Avolites LTD Engineering Change Notice

ECN title	TNP Touch sensor pcb replacement		
ECN Number	ECN-0223		
Related Products	TNP		
Date / Author	31/10/2025	Grzegorz Ksiazka	
Reasons for ECN	Rusty 6way SM connector on TNP 1201-7330-3 board		
Parts required	1x PCB TNP 7330DA-3 (1201-7330DAS-3) 2x Sems SCREW M3 X 8 PAN SUPA ZN/CLR (0210-2082-SM) 1x TNP LVDS loom 3D printed holder (1394-0021) 8x CABLE TIE 98x 2.5 Black (04-03-0043) – spares included 3x NUT M3 NYLOC Z/CLR (0213-1240)		
Tools required	Flexible or short PZ1 screwdriver PZ2 screwdriver 5.5 mm nutrunner Side cutters Insulation tape Methylated spirit		
Estimated time	30 minutes

1. Reason for change

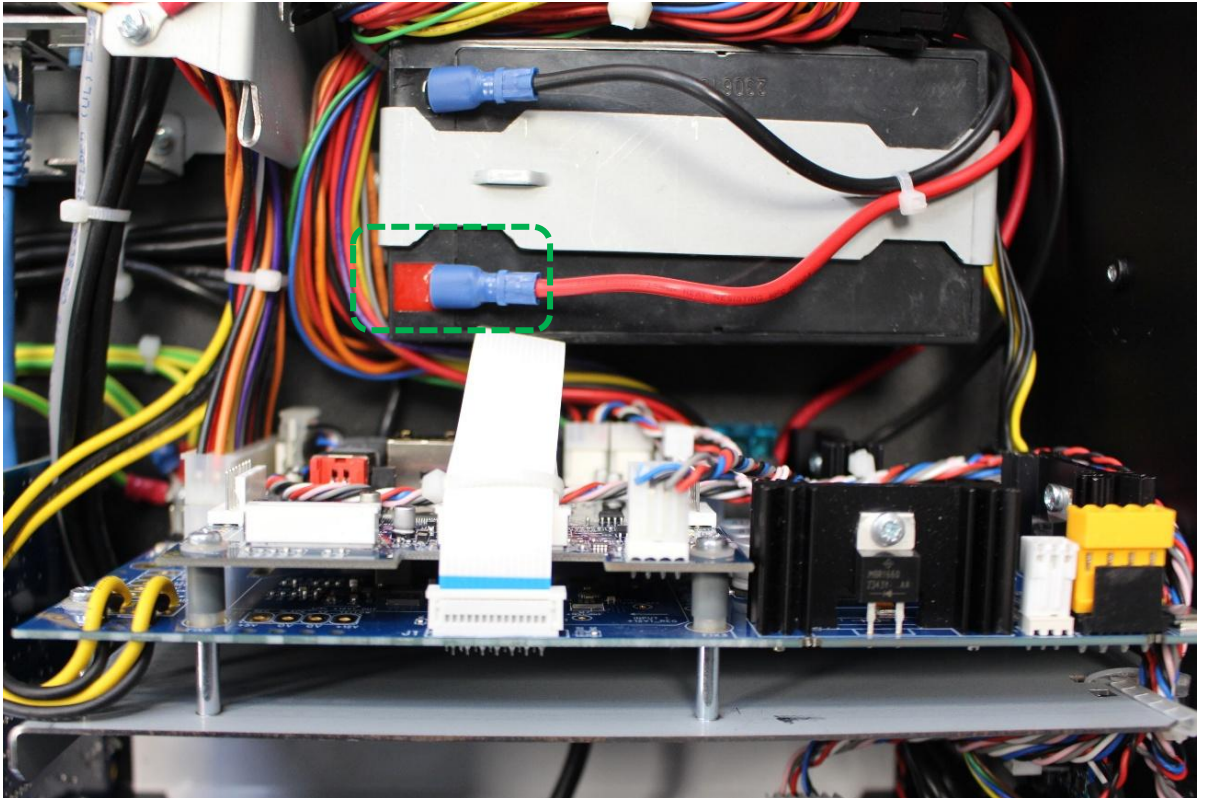
Front panel touch issues like touch sensor doesn't work or license not found. Caused by rusty 6way SM connector on Touch board - TNP 1201-7330-3 board
